The Secretary,  
An Bord Pleanála,  
64 Marlborough Street,  
Dublin 1

Ref; Submission regarding the inclusion of O'Hanlon's Lane as part of the route of the Broadmeadow Way. Ref PL06F.304624

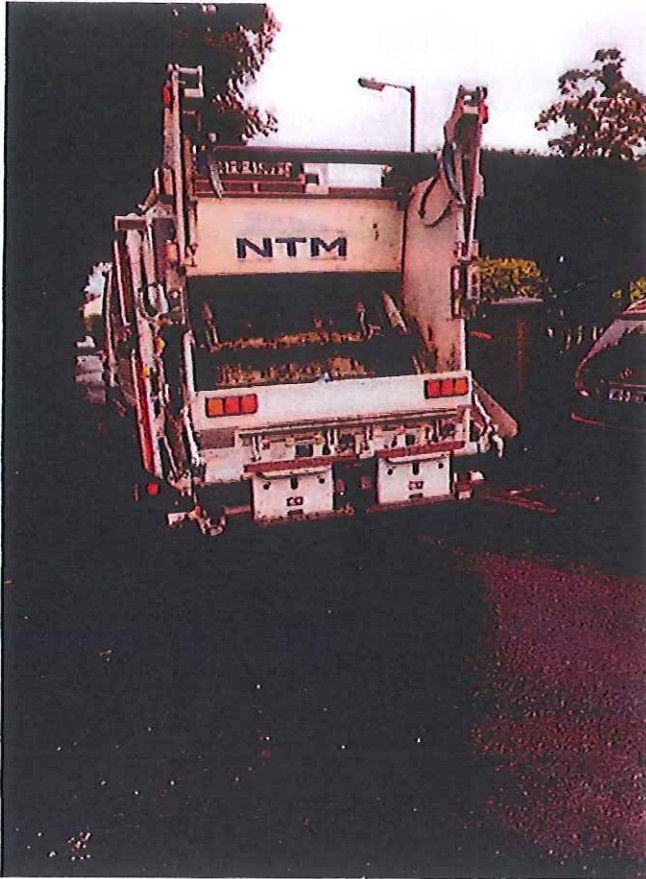
This photo was taken on 17 July 2019 and shows the waste truck, stationary, as it picks up waste from 3 houses. The truck then moves into the position shown in the next photo, where it picks up waste from 4 houses. It's a one-man operation and while this process is taking place it is impossible for anyone, other than pedestrians to pass the truck. Vehicles and cyclists entering the lane wait behind the truck and vehicles and cyclists heading south wait in a wider part of the lane until the truck has passed. Residents are familiar with this, but we feel that introducing numbers like those envisaged by the BMW proposal will make it a more serious issue. We don't believe it helps make the lane meet the criteria for a shared surface and feel that it creates significant safety hazards and also significantly adds further inconvenience to those who use the lane on a daily basis .....the residents.

The truck stops here and picks up waste from 4 houses. It then goes farther and picks up from remaining 7 houses before turning and making its way back to the Dublin Road.

We are afraid that with the introduction of huge numbers of cyclists and pedestrians, there will be accidents and injuries. There will certainly be increased inconvenience for the service provider and the residents and we're afraid that the contractor will withdraw the service.
